SELECTED PROJECT SAMPLE 01 | ELECTRICAL

Quantity Takeoff & Estimate Package

Wellness studio build-out, California

Reference excerpt: E-1 Lighting plan

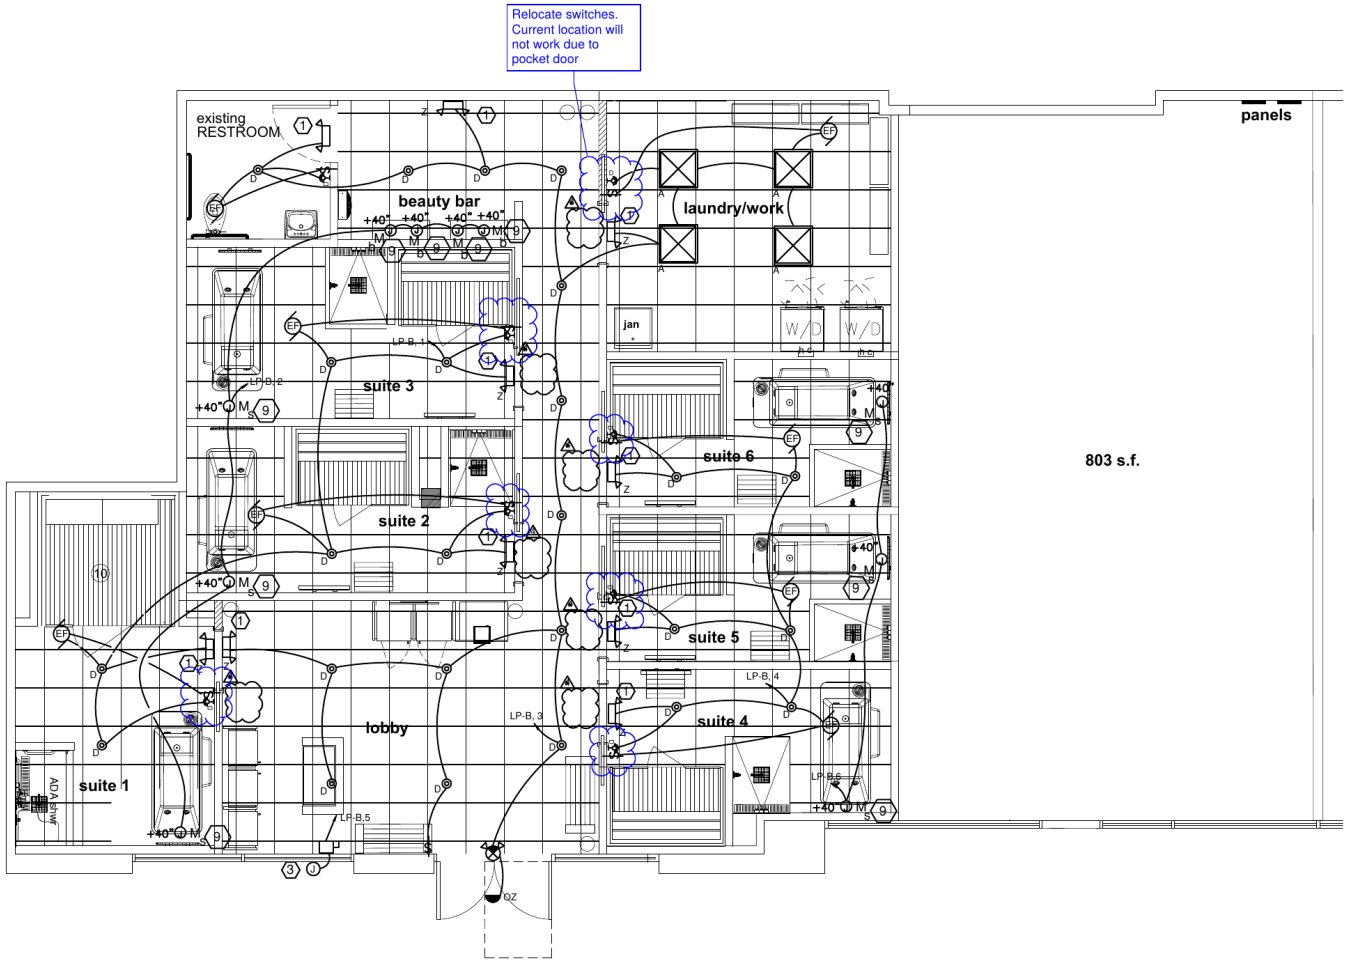
ID	Question	Sheets	Status
RFI-01	Governing bid set, missing Sheet A-2.1, unresolved review comments on E-1 / E-2	A cover, A-2, E-1, E-2	Issued; no response recorded at package date
RFI-02	Existing 400A service and reusable panel conditions (make, AIC, breaker inventory)	A-1.3, E-4	Issued; no response recorded at package date
RFI-03	Structured cabling, AV and camera responsibility; owner cabling and device schedule	A-1.3, E-0, E-2	Issued; no response recorded at package date
RFI-04	Final fixture and backlit-mirror schedule; emergency/exit quantities	E-1, EN-1	Issued; no response recorded at package date
RFI-05	Title 24 controls package and who carries acceptance testing and forms	EN-1, EN-2, E-4	Issued; no response recorded at package date
RFI-06	Electrical demolition and life-safety plan for the ~803 SF separation area	A-2, E-1, E-2	Issued; no response recorded at package date
RFI-07	Backlit suite-number signs: who furnishes, and the power / final-connection boundary	E-1	Issued; no response recorded at package date

Excerpt of the project drawings with title block and project identifiers removed. Blue markups are the design team's review comments as they appeared in the issue set (see RFI-01, RFI-04, RFI-07).

Reference excerpt: E-2 Power floor plan

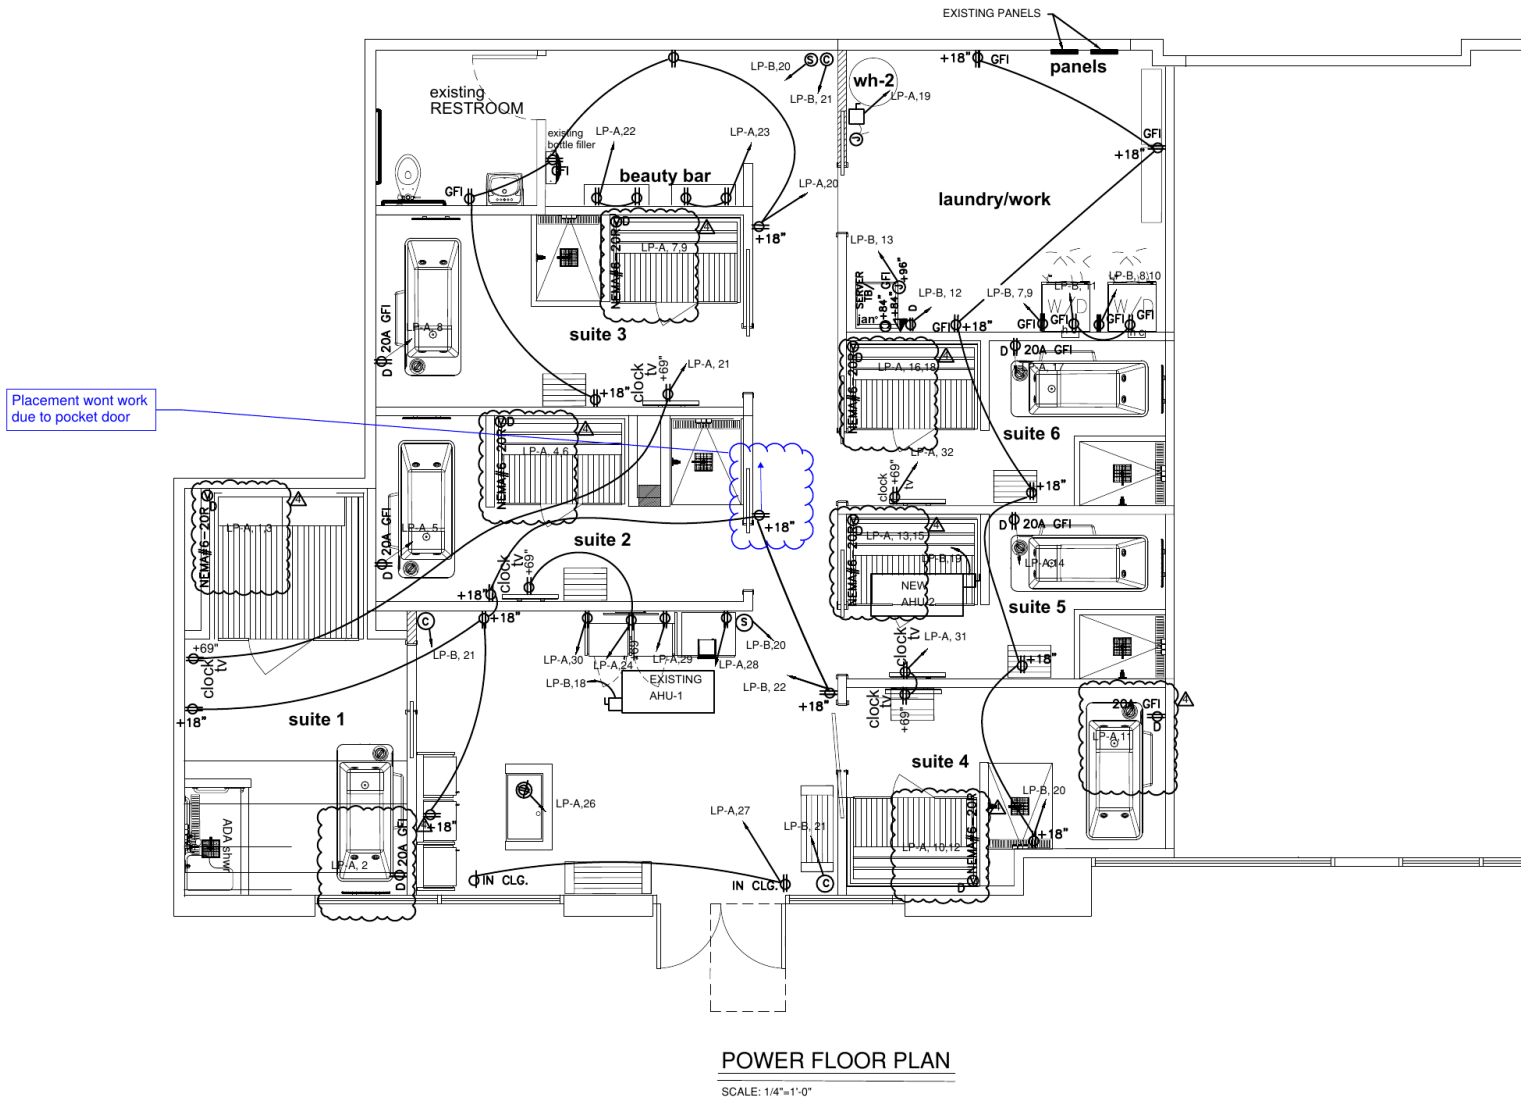
Excerpt of the project drawings with title block and project identifiers removed (see RFI-02, RFI-03, RFI-06).
